GRADING AND DRAINAGE PLAN - OVERALL

ALBUQUERQUE BIOPARK ZOO
PENGUIN EXHIBIT
Albuquerque, New Mexico

OVERALL GRADING AND DRAINAGE PLAN

GRADING AND DRAINAGE PLAN - LOWER LEVEL

CG-102

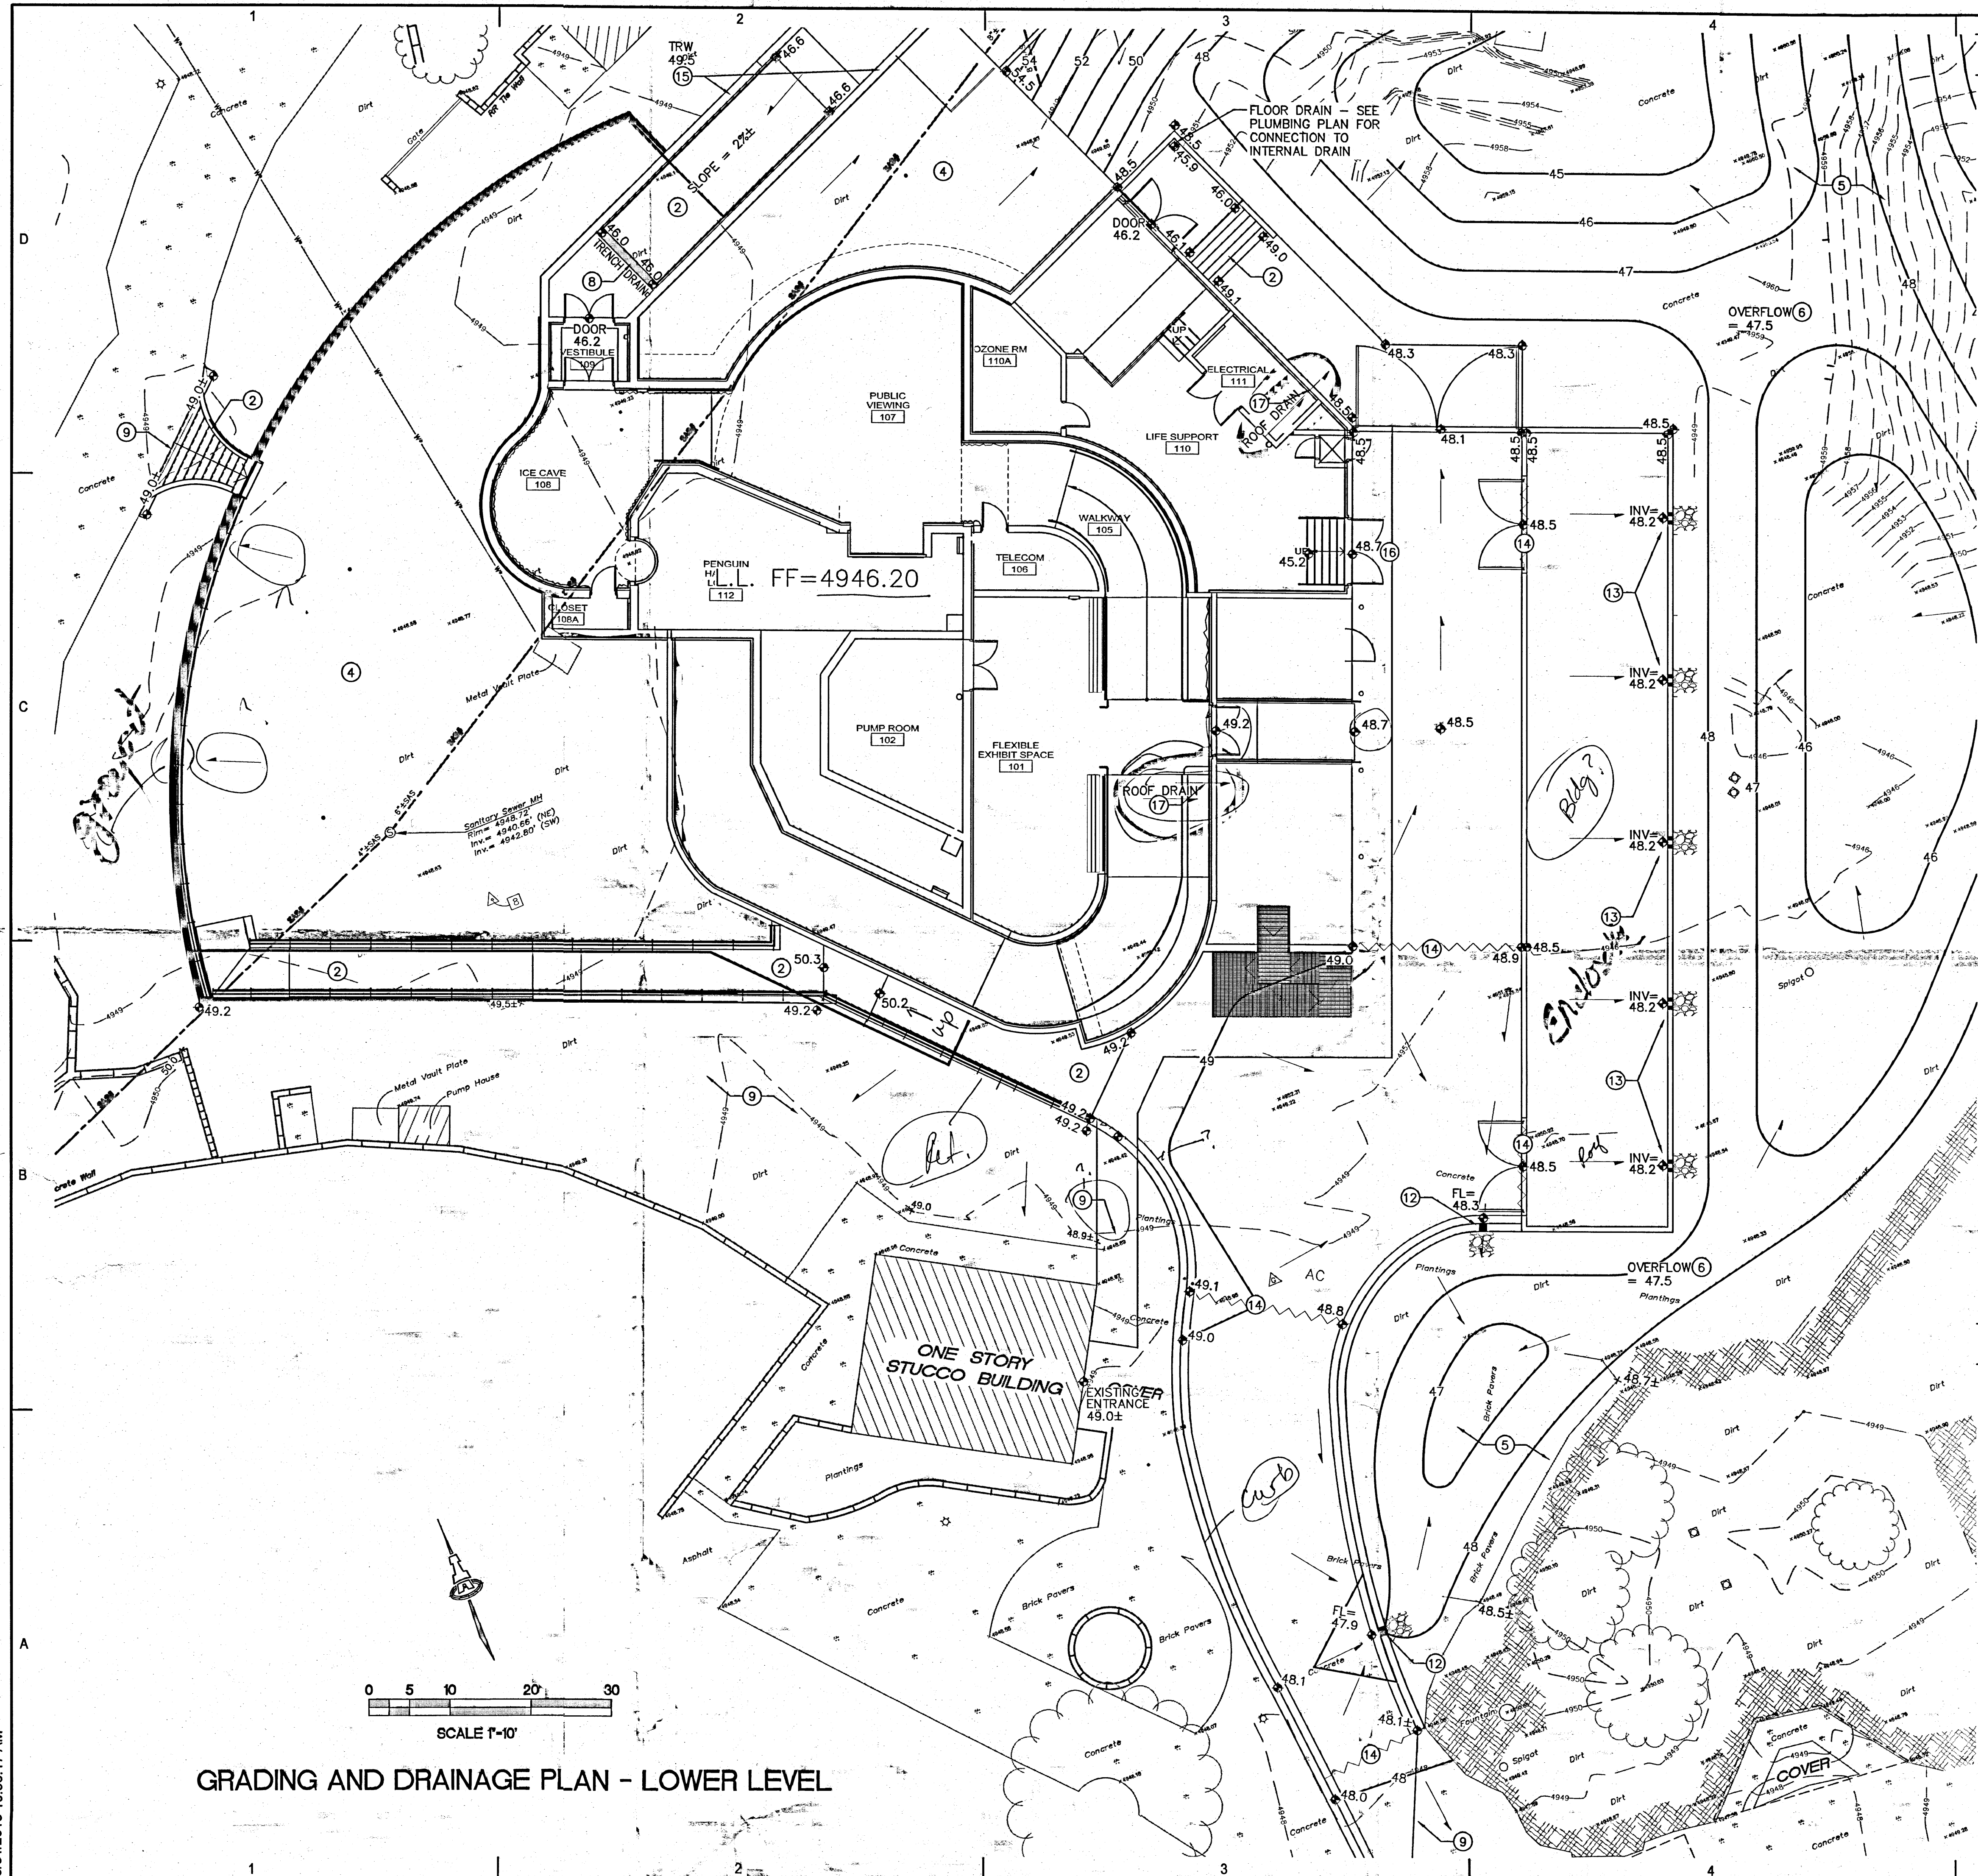
6. OVERFLOW BETWEEN WATER HARVESTING BASINS = 47.5.
 7. NOT USED
 8. SEE ARCHITECTURAL FOR TRENCH DRAIN WITHIN WALK LOW POINT THIS AREA - SEE MECHANICAL PLANS FOR CONNECTION TO SANITARY SEWER SYSTEM. *cannot put in sewer*

6. OVERFLOW BETWEEN WATER HARVESTING BASINS = 47.5.
 7. NOT USED THIS SHEET
 8. TRENCH DRAIN AND FLOOR DRAIN NOTED WILL BE CONNECTED TO BUILDING SANITARY SEWER SERVICE LINE. SEE PLUMBING PLANS FOR ADDITIONAL INFORMATION.
